NUMBER: 81-2

DATE: 3/6/81

- A. Insufficient Engine Intake Air
- B. MCM 470-485 Torque Specification Change
- C. Quadrajets Carburetor Rough Idle

**Figure 1. Air Vent Tube Location
in Quadrajets Carburetor**

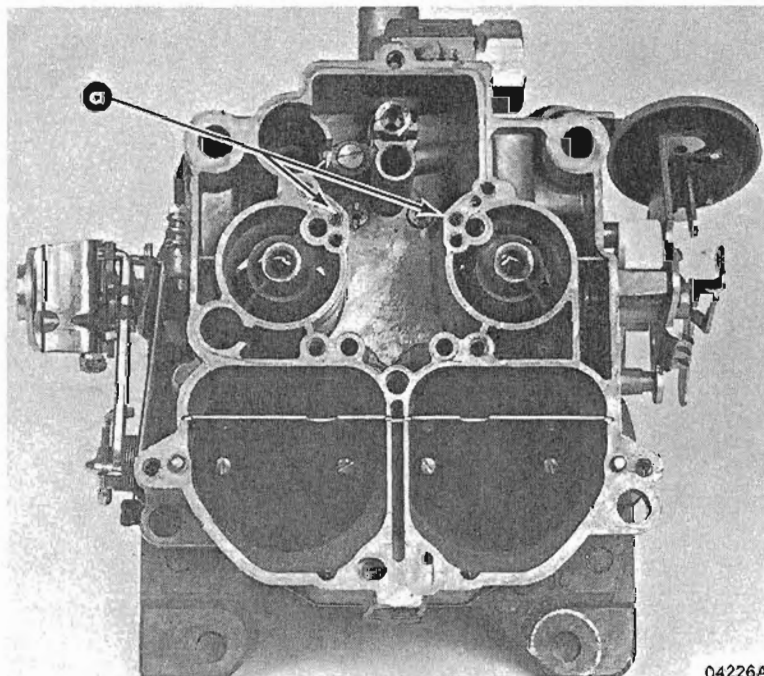
Our Service Department checked several Quadrajets Carburetors (MerCruiser 228-260) that were sent in for warranty. The complaint was engines would not idle smoothly and could not be adjusted with the idle adjustment screws. It was determined, the idle air vent tubes were plugged. To correct this problem, run a fine wire through the vent tubes. (See Figure 1 for location.) Smaller wire than the opening at the bottom of the tube must be used. The vent tubes are tapered down smaller at the bottom.
